SIB 61 23 20

RECALL 20V-601: HIGH-VOLTAGE BATTERY

This Service Information Bulletin (Revision 3) replaces SI B61 23 20 **dated December 2020**.

What's new:

G05 modules are POS or NEG

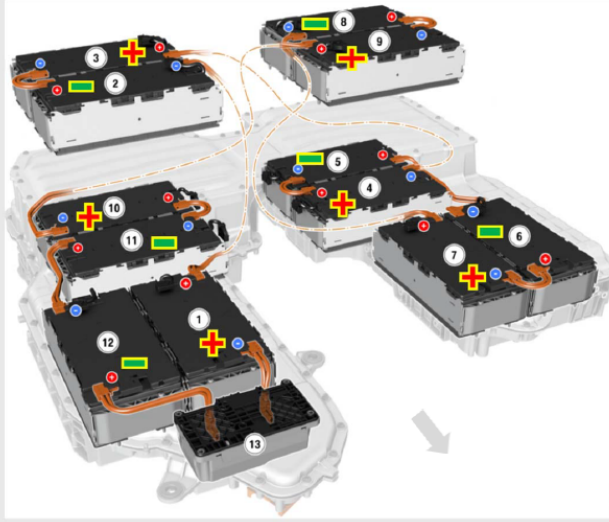
Illustration below is new:

Use EPC diagram to order the correct module polarity. The correct locations of the modules are displayed in illustration.

- Module 12 is **NEG**
- Module 1 is **POS**
- Module 11 is **NEG**
- Module 10 is **POS**
- Module 2 is **NEG**
- Module 3 is **POS**
- Module 8 is **NEG**
- Module 9 in **POS**
- Module 5 is **NEG**
- Module 4 is **POS**
- Module 6 is **NEG**
- Module 7 in **POS**
